City of Tualatin

Self-Evaluation and Transition Plan: Appendix A: ADA Task Force Meeting Agendas

Self-Evaluation and Transition Plan:
Appendix C: Standard Plan and Specification
Review and Recommendations

CONCRETE SIDEWALK

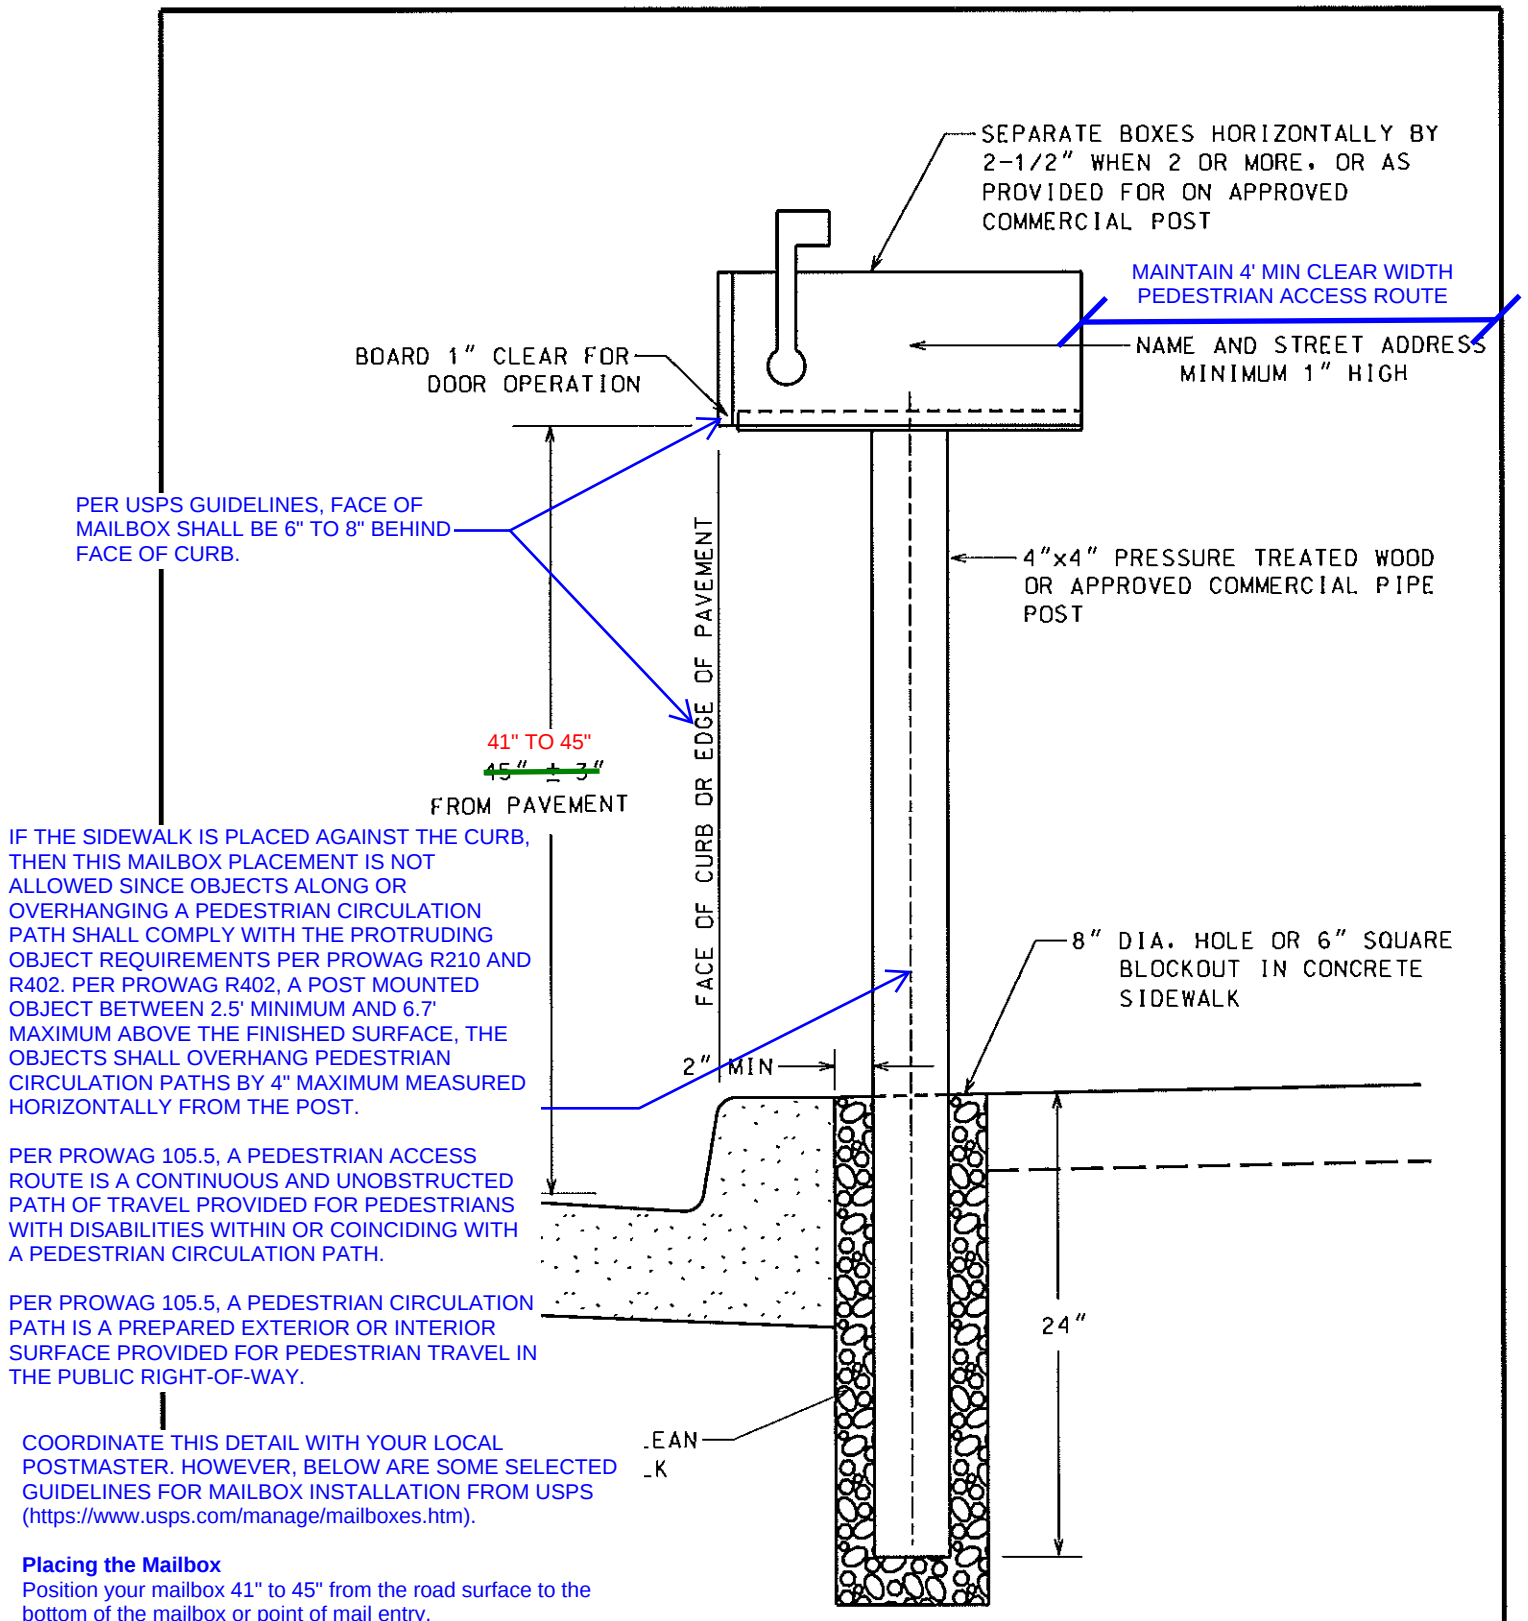
REVISED TO 1/8" MAX RADIUS TO ALLOW FOR CONSTRUCTION OF A 1/2" MAXIMUM HORIZONTAL OPENING IN SIDEWALK PER PROWAG R302.7.3.

REVISED TO 1/4" JOINT FILLER TO ALLOW FOR CONSTRUCTION OF A 1/2" MAXIMUM HORIZONTAL OPENING IN SIDEWALK PER PROWAG R302.7.3.

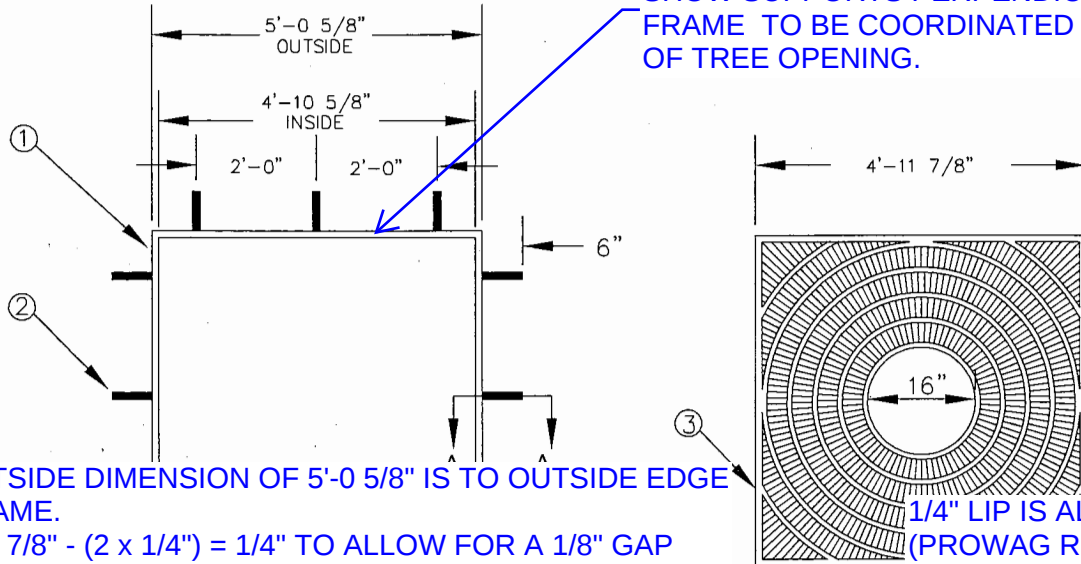
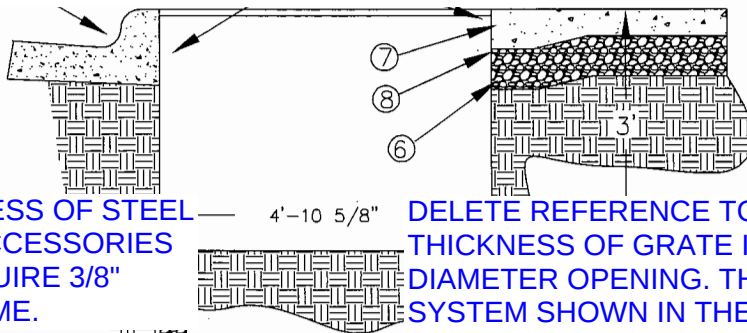
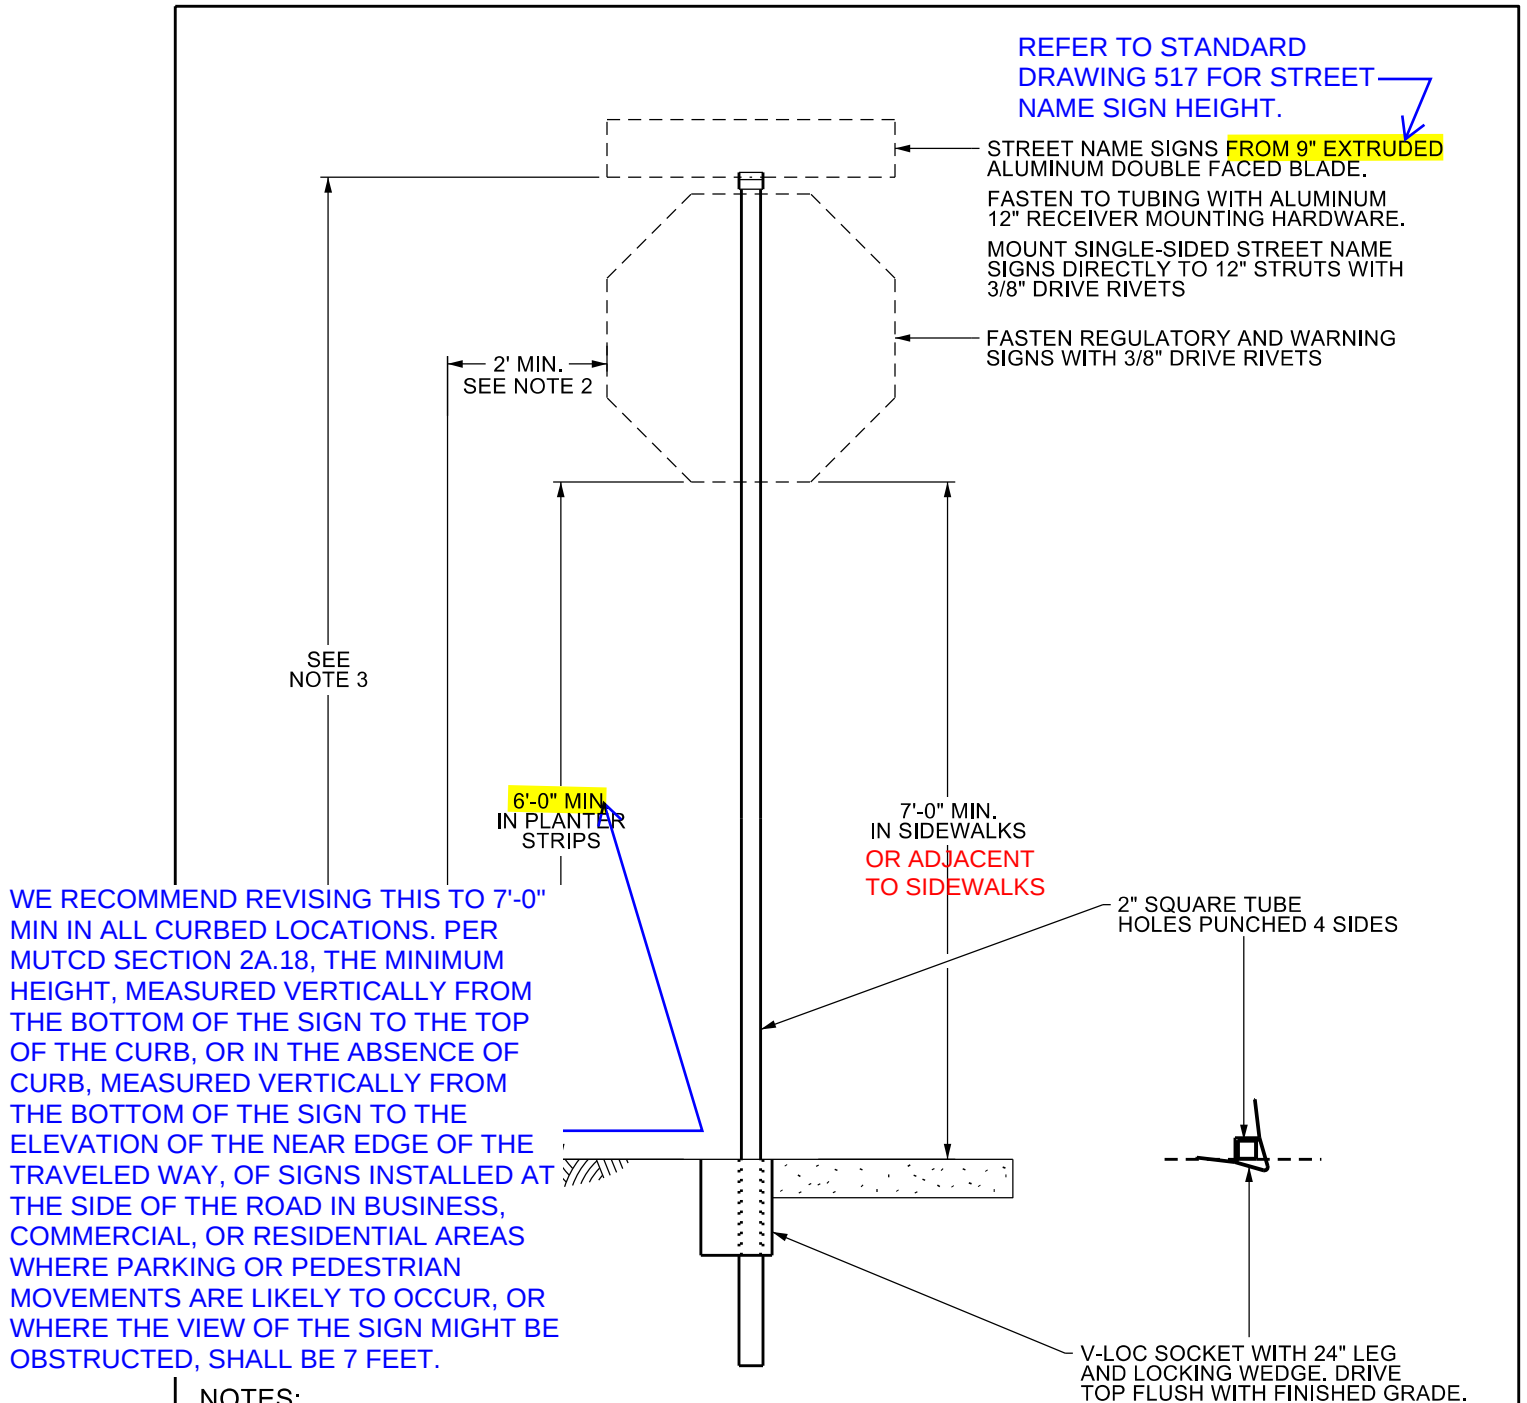
URBAN ACCESSORIES TYPE "S" FRAME SHOW SUPPORTS PERPENDICULAR TO FRAME TO BE COORDINATED WITH SIZE OF TREE OPENING.

CONFIRM OUTSIDE DIMENSION OF 5'-0 5/8" IS TO OUTSIDE EDGE OF STEEL FRAME.

$5'-0 \frac{5}{8}" - 4'-11 \frac{7}{8}" - (2 \times \frac{1}{4}) = \frac{1}{4}"$ TO ALLOW FOR A $\frac{1}{8}"$ GAP BETWEEN FRAME AND GRATE WHICH MEETS THE $\frac{1}{2}"$ MAXIMUM ALLOWED OPENING (PROWAG R302.7.3). HOWEVER, DIMENSIONS OF URBAN ACCESSORIES FRAME AND GRATE VARY SLIGHTLY FROM WHAT IS SHOWN IN THIS DETAIL BUT STILL INDICATES A $\frac{1}{8}"$ MAX GAP.

$\frac{1}{4}"$ LIP IS ALLOWED (PROWAG R302.7.2) BUT FRAME FLUSH WITH ADJACENT PAVEMENT IS PREFERRED.

CONFIRM THICKNESS OF STEEL FRAME. URBAN ACCESSORIES APPEARS TO REQUIRE $\frac{3}{8}"$ THICK STEEL FRAME.

DELETE REFERENCE TO POLY-GRATE II. THICKNESS OF GRATE IS 2" WITH A 12" DIAMETER OPENING. THE FRAME SYSTEM SHOWN IN THEIR SUGGESTED SPECIFICATIONS DOES NOT INDICATE AN L SHAPED STEEL FRAME. GRATE WOULD BE STICKING ABOVE FRAME REQUIRED IN THIS DETAIL.

MATERIAL SHOULD BE FIRM AND STABLE (PROWAG R302.7). GRATE SHOULD NOT FLEX IF STEPPED ON.

CONFIRM MINIMUM DEPTH OF TREE ROOT BARRIER. BIOBARRIER RECOMMENDS 19.5" DEPTH ADJACENT TO SIDEWALK AND CURB WHILE DEEPROOT RECOMMENDS 24" DEPTH ADJACENT TO CURB AND GUTTER (COORDINATE WITH CITY'S ARBORIST).

UPDATE NOTE 3. URBAN ACCESSORIES FAN DESIGN TREE GRATE IS CAST INTO 4 PIECES WITH OPENINGS NO GREATER THAN $\frac{1}{2}"$ WIDE.

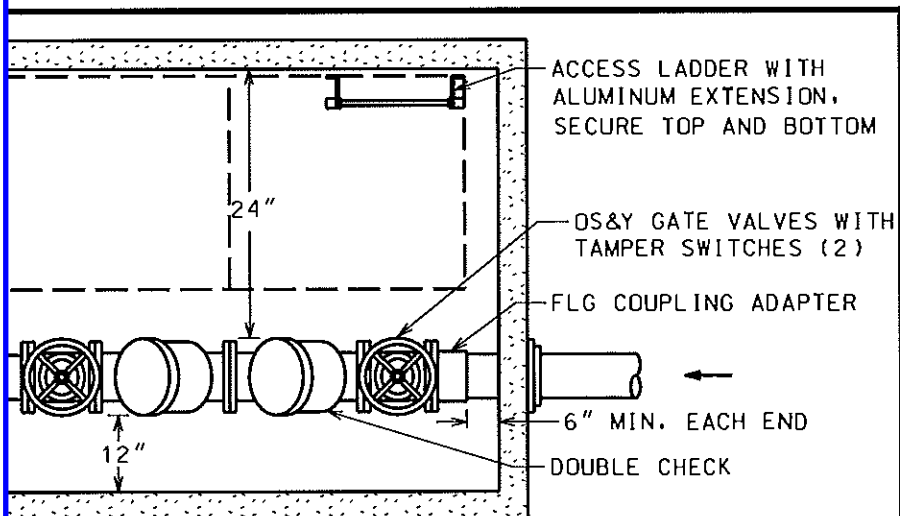
CONFIRM IF THIS IS ALLOWED TO BE INSTALLED IN THE RIGHT OF WAY.

AVOID LOCATING STRUCTURES IN THE PEDESTRIAN PATH OF TRAVEL.

IF STRUCTURES ARE REQUIRED TO BE LOCATED IN THE PEDESTRIAN PATH OF TRAVEL DUE TO EXISTING CONSTRAINTS, THE STRUCTURES MUST ADHERE TO PROWAG'S SURFACE REQUIREMENTS.

**DOUBLE CHECK DETECTOR
FIRE PROTECTION
WITHOUT FDC**

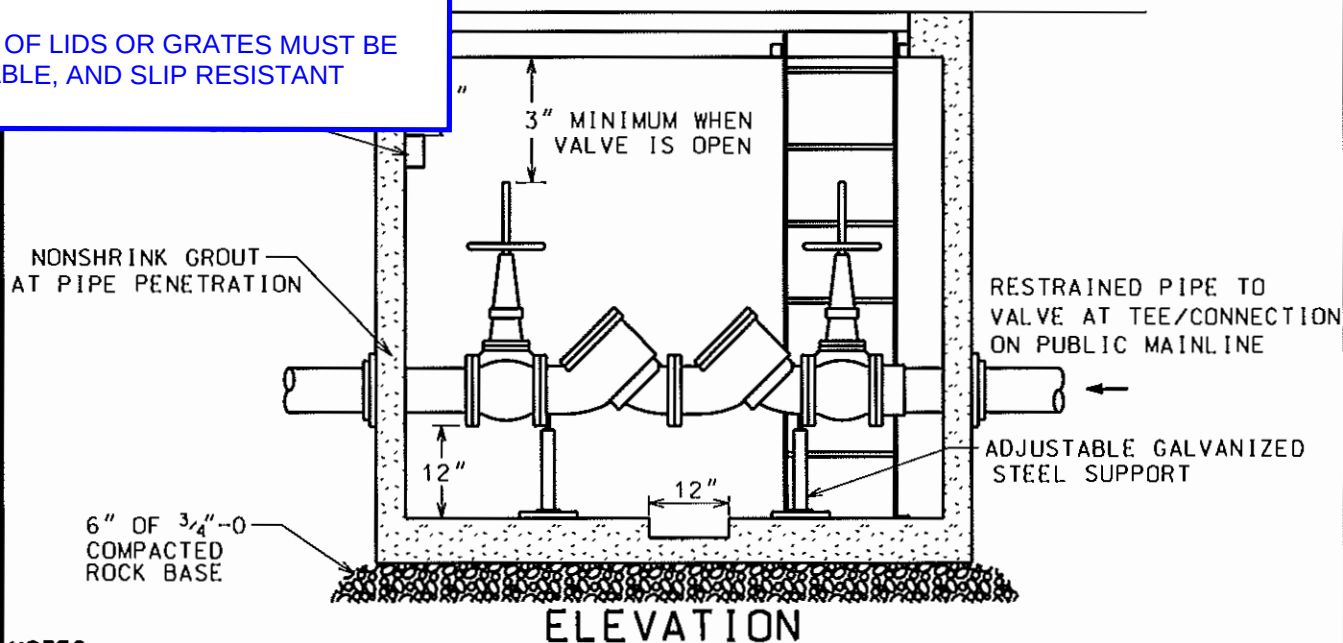
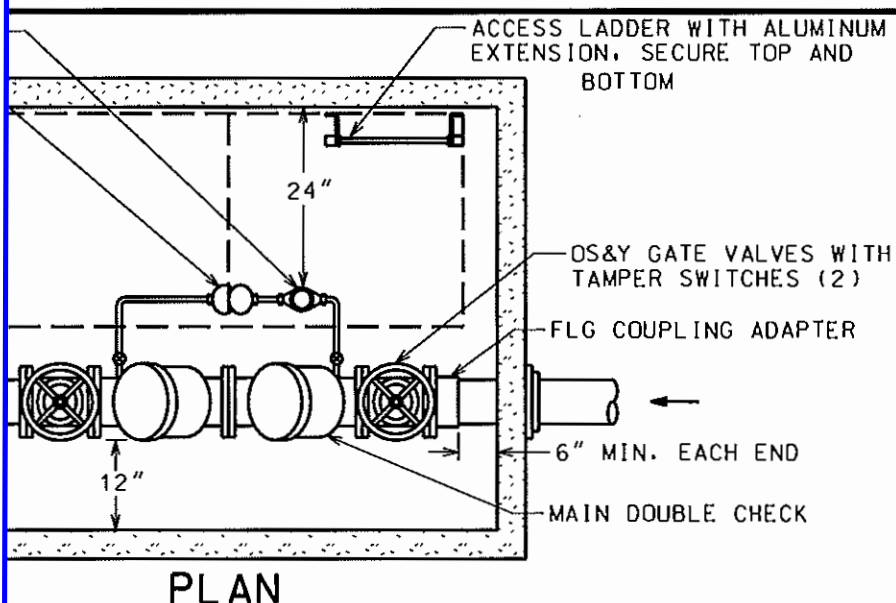
CONFIRM IF THIS IS ALLOWED TO BE INSTALLED IN THE RIGHT OF WAY.

AVOID LOCATING STRUCTURES IN THE PEDESTRIAN PATH OF TRAVEL.

IF STRUCTURES ARE REQUIRED TO BE LOCATED IN THE PEDESTRIAN PATH OF TRAVEL DUE TO EXISTING CONSTRAINTS, THE STRUCTURES MUST ADHERE TO PROWAG'S SURFACE REQUIREMENTS.
